ADDENDUM NO. 1

DATE: November 18, 2015
FROM: City of Grand Junction Purchasing Division
TO: All Offerors
RE: City Hall Server Room Relocation Project – Phase 1 IFB-4138-15-DH

✓ SCR-64

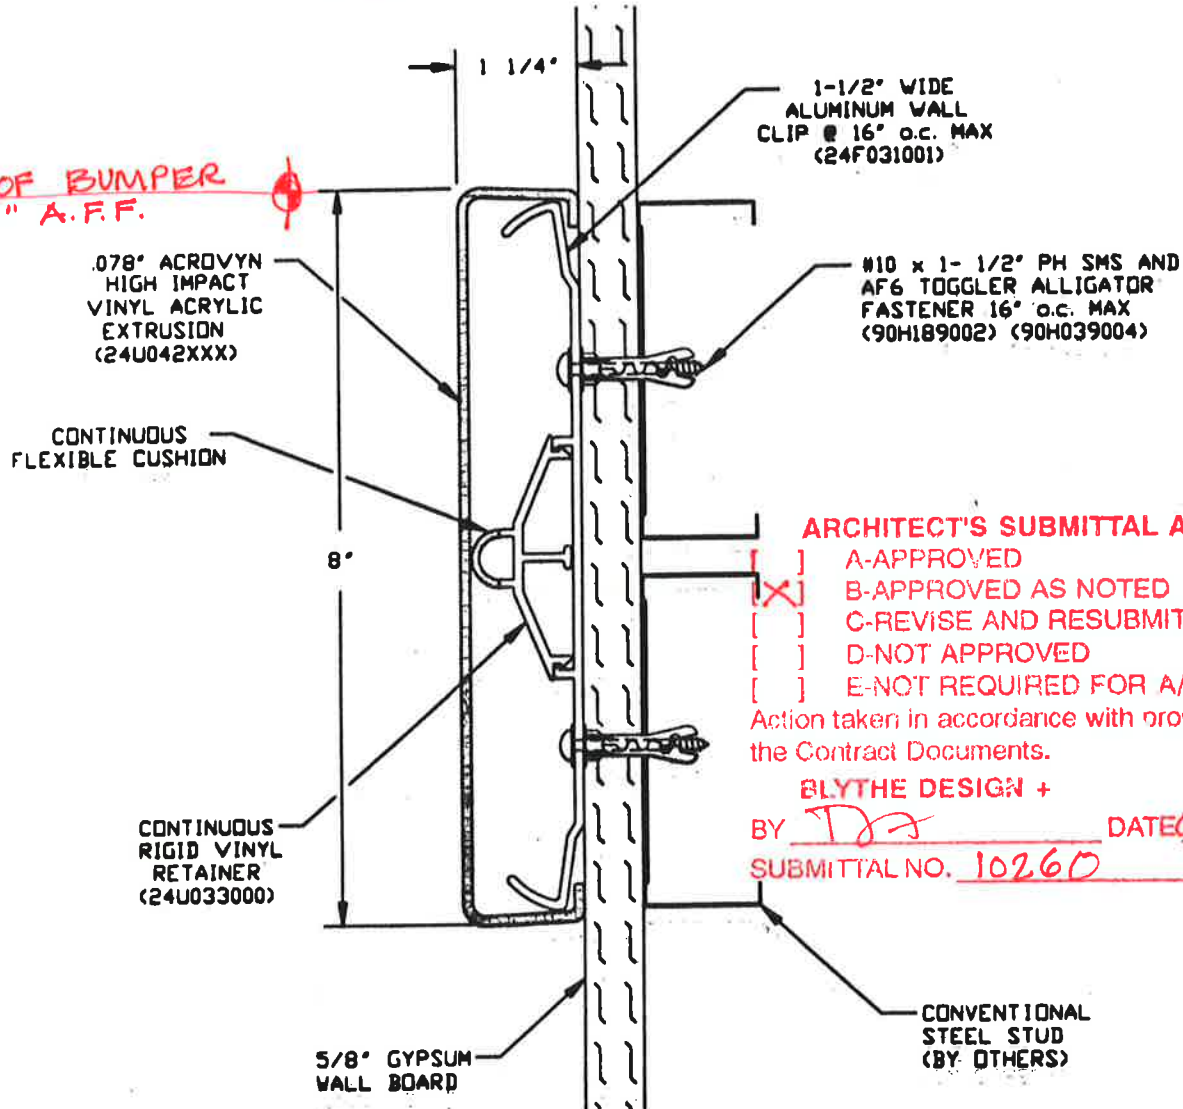
- j. In corridor 122 modify the existing chair rail to accommodate the larger door opening.
10. See attached Chair Rail Detail Drawing.

TOTAL L/F REQ'D	20' REQ'D	END CAPS	O.S. REQ'D	ODD' O.S.
(84 LF)		16 ✓

Field Verity Length
this may be too much

TOP OF BUMPER
@ 36" A.F.F.
